Subject: MASTER WARNING LIGHT IS ON AND INSTRUMENT CLUSTER WARNING MESSAGE IS DISPLAYED (DTC P1794 AND P2502)	Bulletin No: 01-001/14
	Last Issued: 02/04/2014

- This bulletin supersedes the previous bulletin 01-001/14, issued 01/24/2014, 01/10/2014 and 01-028/13, issued on 11/19/2013. The APPLICABLE MODEL(S)/VINS and CALIBRATION INFORMATION have been revised.
- Changes are noted below in Red beside the change bar.

2. Symptom

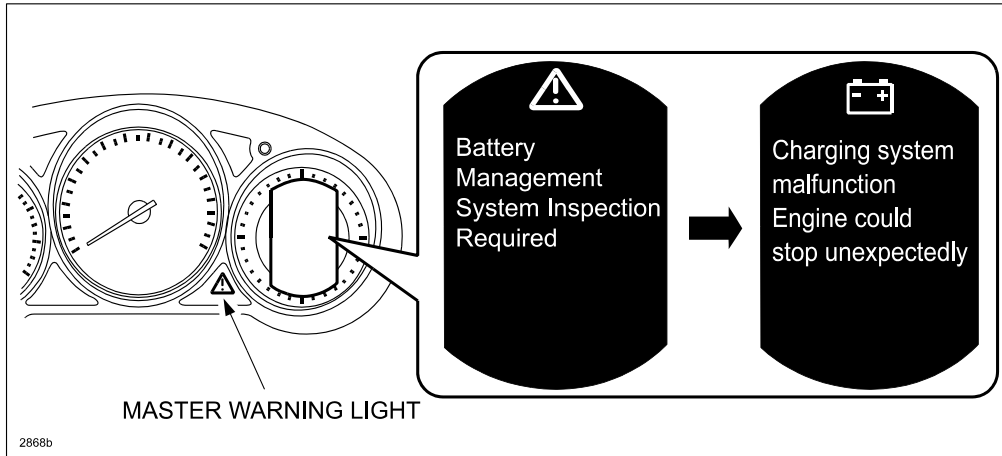
- a. Warning message “Battery Management System Inspection Required” and then "Charging System Malfunction/Engine could stop unexpectedly" is displayed in the instrument cluster information display after driving in the rain.
- b. The Master warning light will be illuminated.

- c. The following DTCs are stored in PCM memory:
 - DTC P1794:00 - Capacitor (i-ELOOP) system: Capacitor (i-ELOOP) malfunction
 - DTC P2502:00 - Generator system: Malfunction in voltage generated by generator

Customers having this concern should have their vehicle repaired using B. REPAIR PROCEDURE.
